## IDENTIFYING CWP WATER SYSTEM MAIN RO PUMP REPLACEMENT PARTS

The purpose of this Technical Update is to understand and identify the various parts required to replace the Main RO pump on the CWP water system.

Version 1:

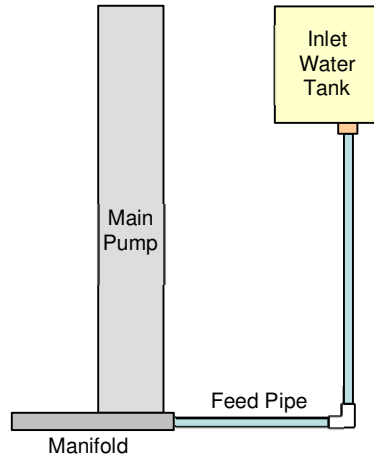
- Dual outlet water tank
- Steep threads in unions
- Dual feed to the pump
  - One feed via the lower manifold
  - An additional feed pipe to the RO pump mid-section

Version 2:

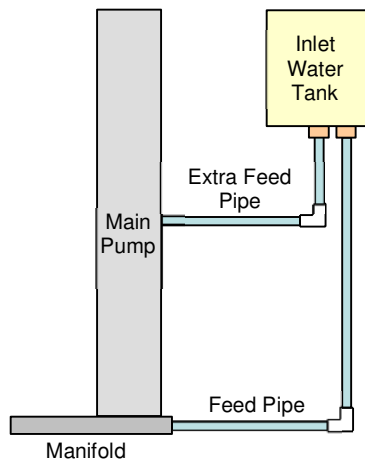
- Dual outlet water tank
- Steep threads in unions
- Dual feed to the pump
  - One feed via the lower manifold
  - Second feed pipe moved to a lower point in the RO pump housing

Version 3:

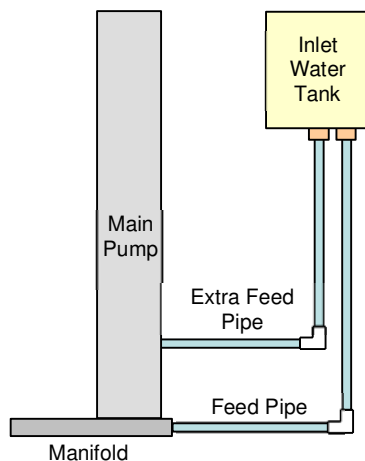
- Single outlet water tank
- Coarse threads in union
- Single feed to the pump via the lower manifold

Version 4:

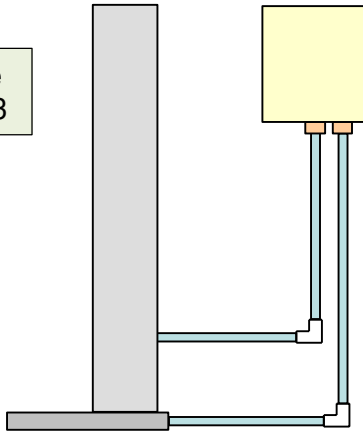
- Electrical changes only

Version 5:

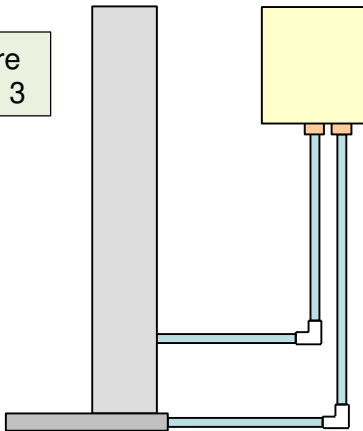
- End cap and wire lead changes

Version 6:

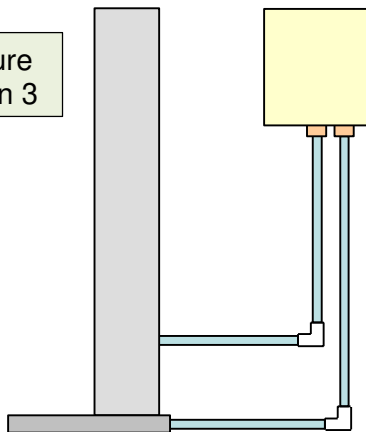
- End cap, wire lead and strain relief changes
- Pump housing change
- Pump pipe change

## Version 1

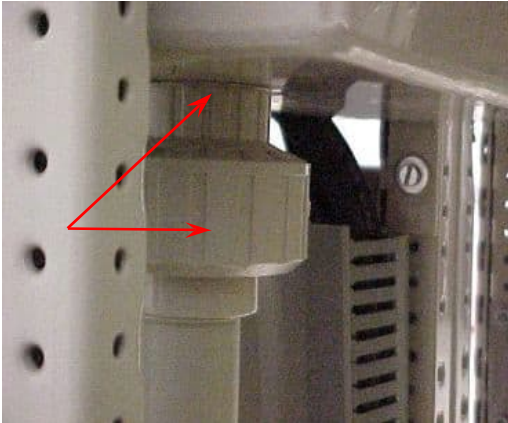
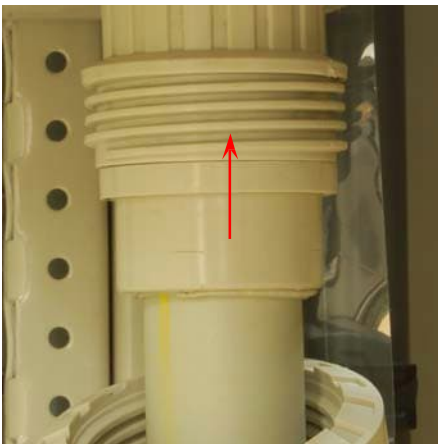
The earlier version of the Inlet Tank had one 25 mm pipe that fed from the bottom of the tank to the bottom of the manifold frame and then to the RO pump.

**Note:** When installing the current RO Pump, all upgrades must be performed.

| Part being replaced:                | Order the following:  |  |
|-------------------------------------|---|--|
| Early style Inlet Water Tank (only) | W3T579433<br>W3T578017  | Inlet Water Tank (new style)<br>Feed pipe steep thread to STD  |
| RO Pump                             | W3T579433<br>W3T578168<br>W3T577645<br>W3T577646<br>W3T577647 | Inlet Water Tank (new style)<br>Extra feed pipe kit C-PVC<br>RO Pump CWP 101 & 102, or<br>RO Pump CWP 103 & 104, or<br>RO Pump CWP 106 |

### Version 4

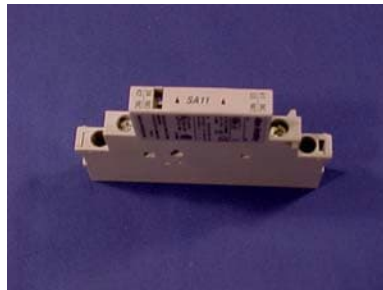
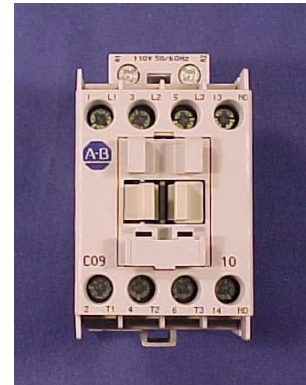
To improve reliability once again, all Main RO Pump motors were changed to a 2.2 kW model. The pump shaft for the new motor was also upgraded to a higher quality material with a smooth shaft.

The power requirements for the CWP 106 remain the same and therefore the 106 can use the same 10-16 amp Motor Protector and Contactor it always has. However, for the CWP 101-104, since the power requirements have increased, the Main RO Motor Protector and Contactor must be upgraded.

The auxiliary contactor is partnered with MCS1 and may be difficult to remove safely without damage. Therefore, it should be ordered as an accessory and changed when MCS1 is changed.

| Part being replaced:               | Order the following:                |   |
|------------------------------------|-------------------------------------|---|
| RO Pump                            | W3T577645<br>W3T577646<br>W3T577647 | RO Pump CWP 101 & 102, or<br>RO Pump CWP 103 & 104, or<br>RO Pump CWP 106 |
| For CWP 101-104 S/N <100292<br>add | W3T577810<br>W3T577809<br>W2T932129 | MCS1<br>CON1<br>AUX Contactor   |
